### STATE OF NEW YORK PUBLIC SERVICE COMMISSION

Case 20-T-0617 Deficiency No. 1

SUNRISE WIND LLC'S RESPONSE TO THE MAY 20, 2021 DEFICIENCY NOTICE

Figure 2.3-2 that includes the required information of 16 NYCRR  $\S86.3(a)(1)(i)$ - (iii) on maps at a 1:24,000 scale showing topographic features.

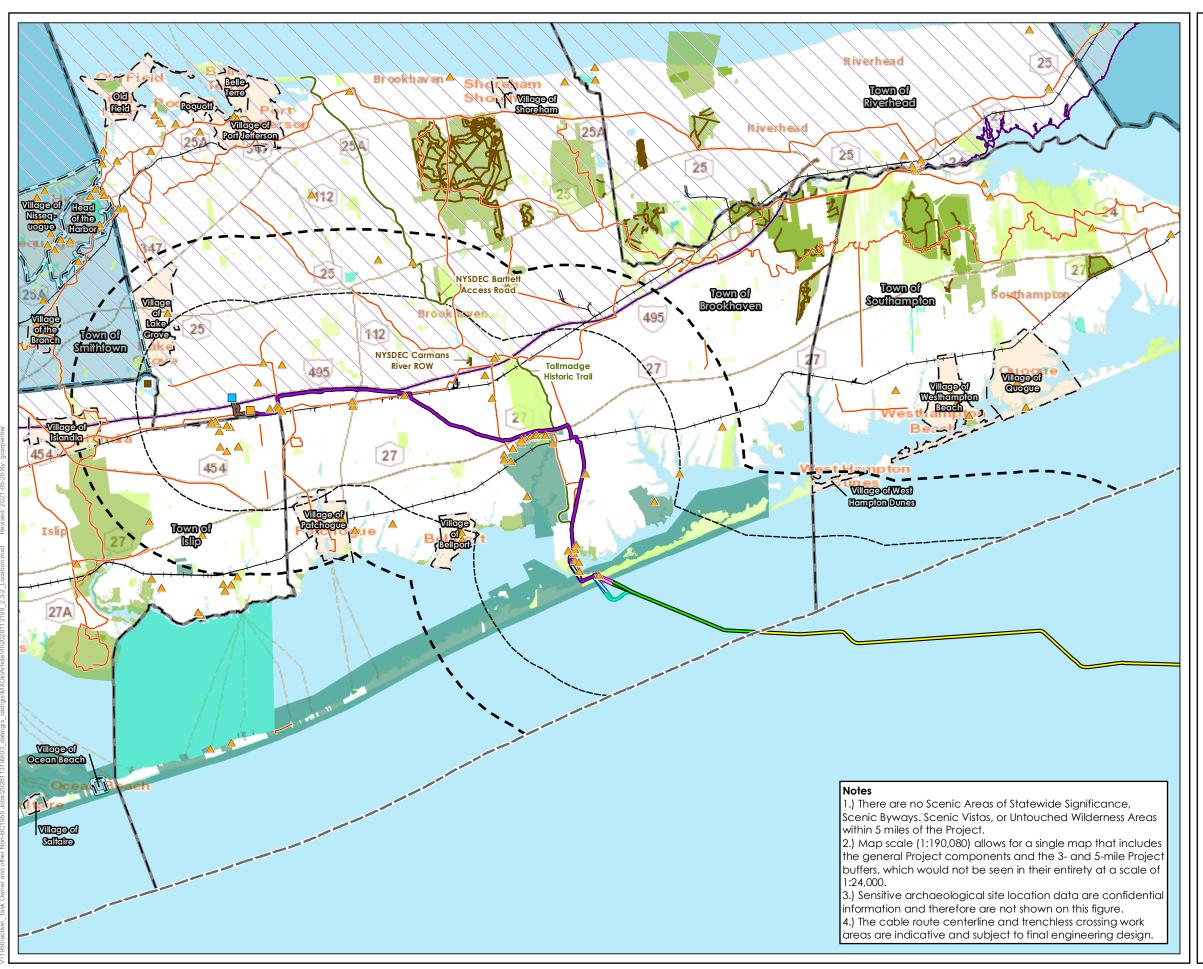
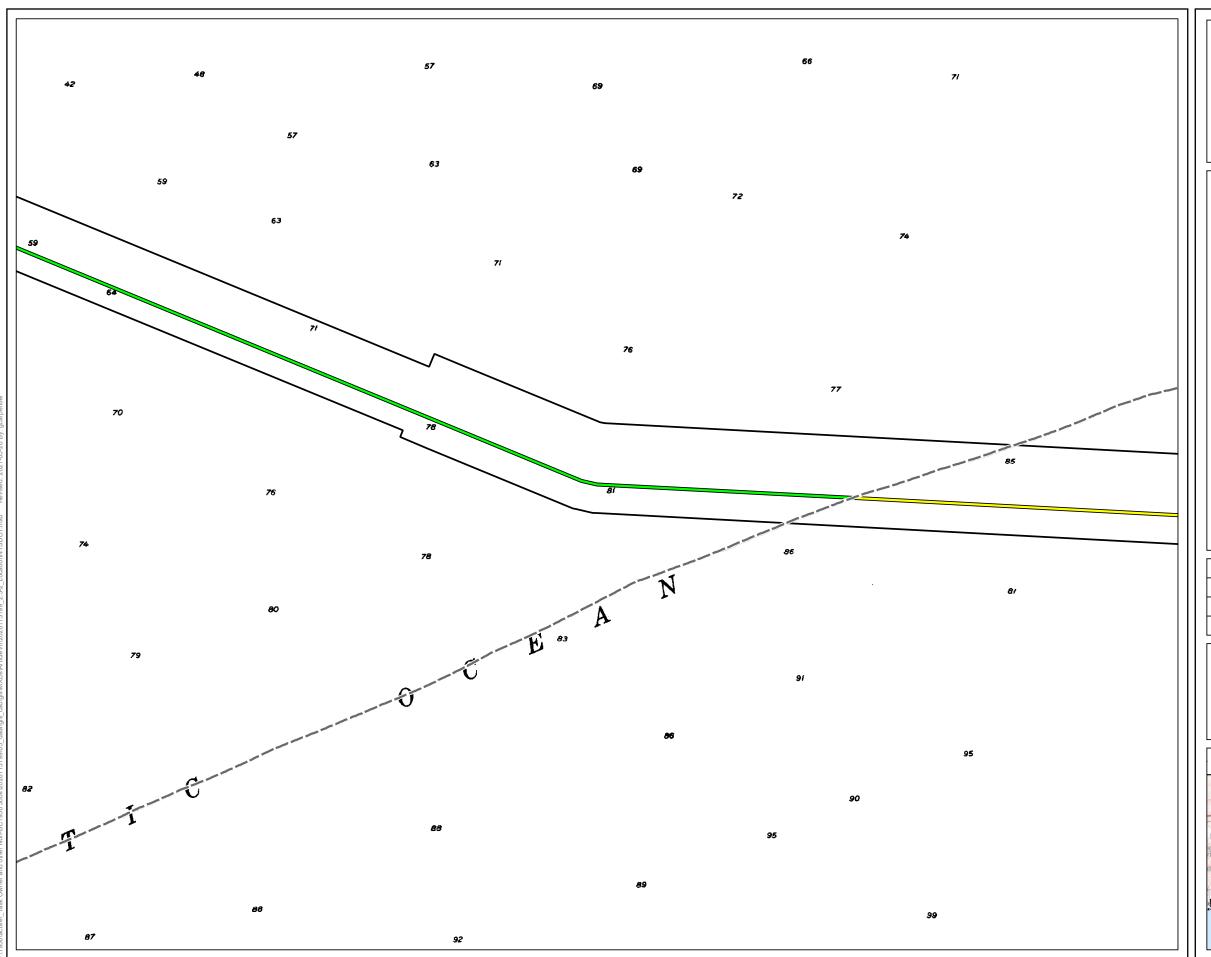
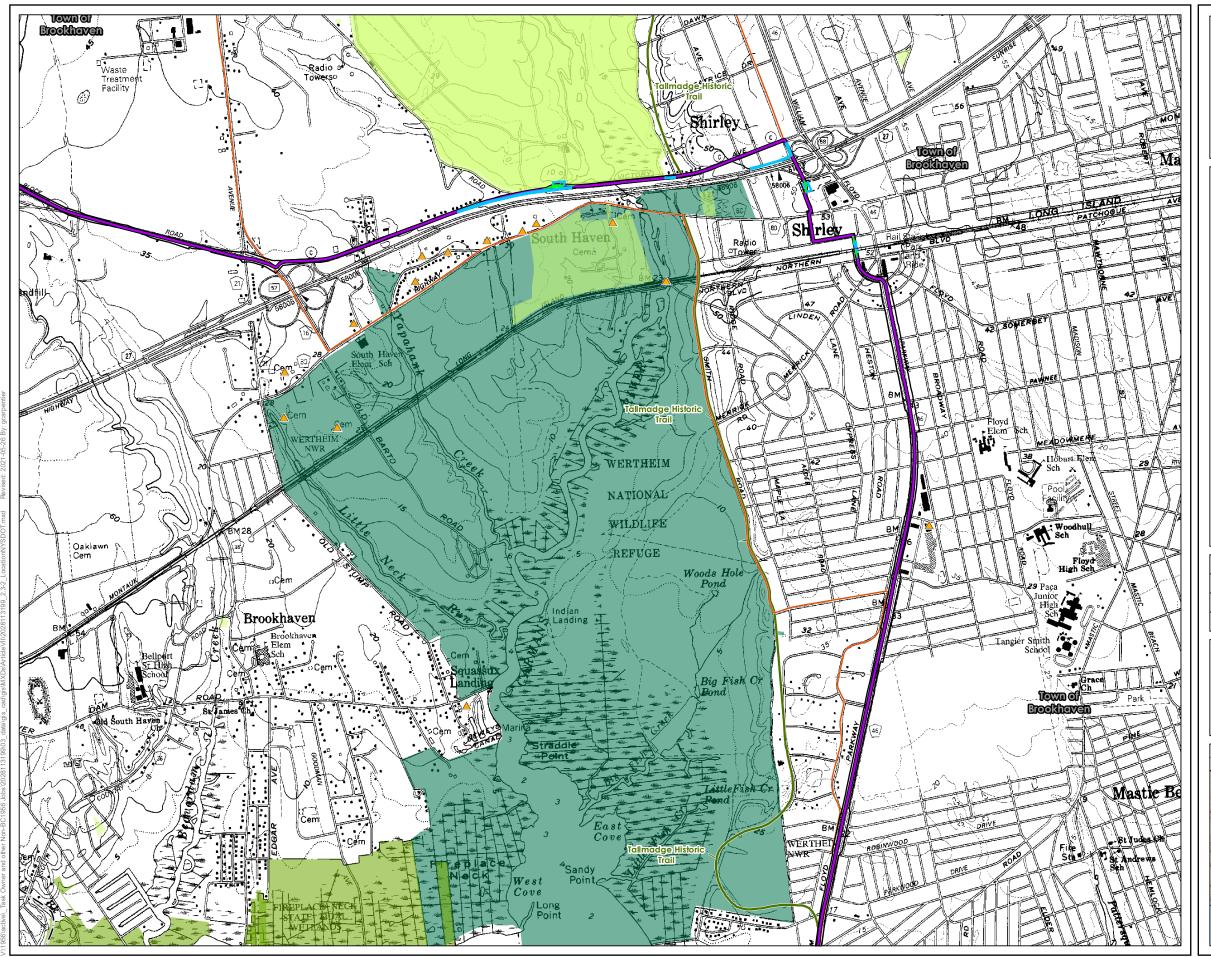
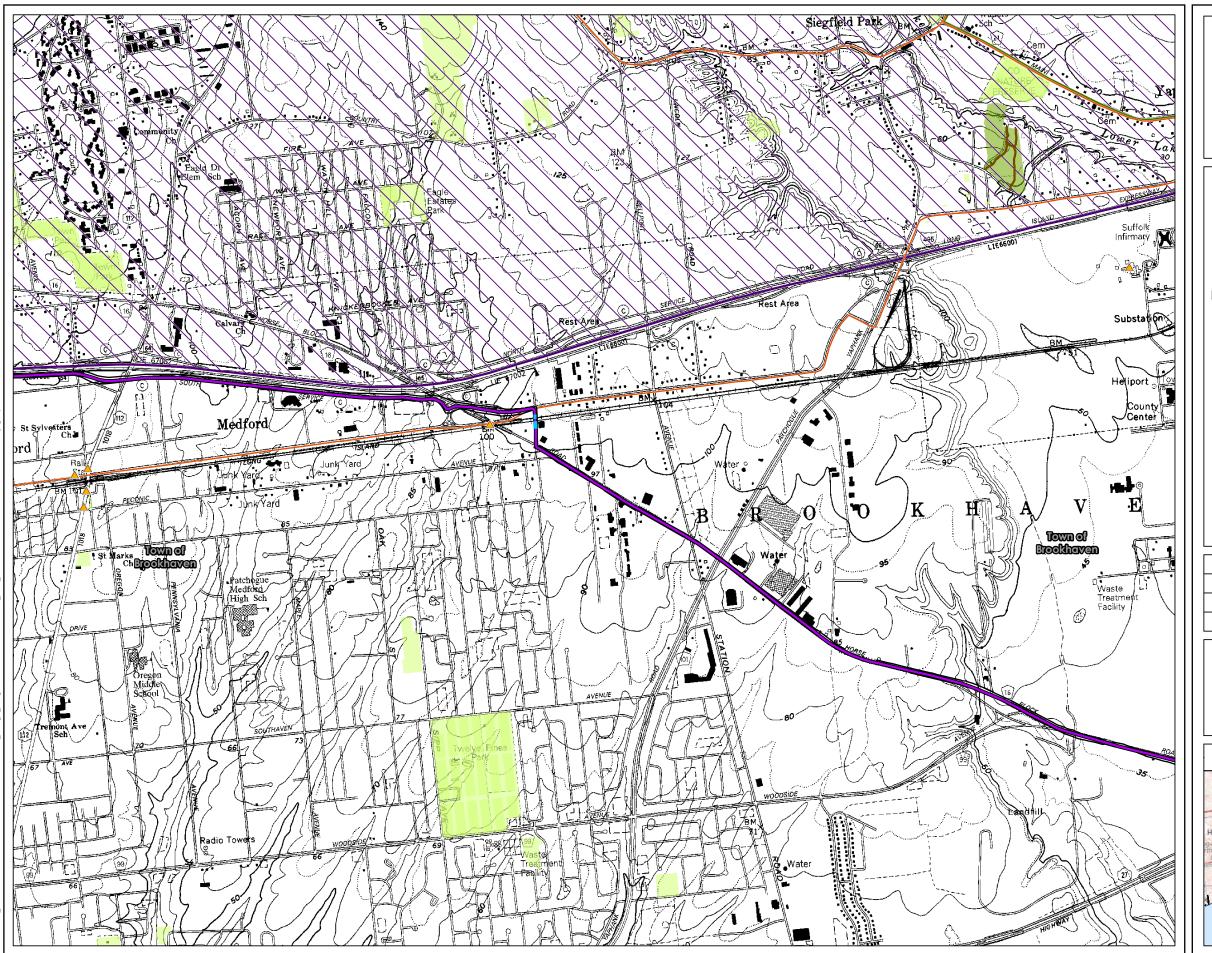
The Deficiency Letter stated that although the Applicant has included a waiver request for the NYSDOT map (1:24,000 topographic edition), the waiver request only addresses the scale requirements and does not provide justification for any waiver of the requirement that the required information be presented on topographic edition maps. Revised Figure 2.3-2 included in the Application Supplement and Amendment appears to include planimetric maps that do not show topographic features. Please provide a further revised

See the enclosed public version of Revised Figure 2.3-2, which has been further updated to include topographic features in full satisfaction of 16 NYCRR § 86.3 (a) (1) (i)-(iii). The confidential version of Revised Figure 2.3-2 will be provided to the presiding Administrative Law Judges with a request for exemption from disclosure.
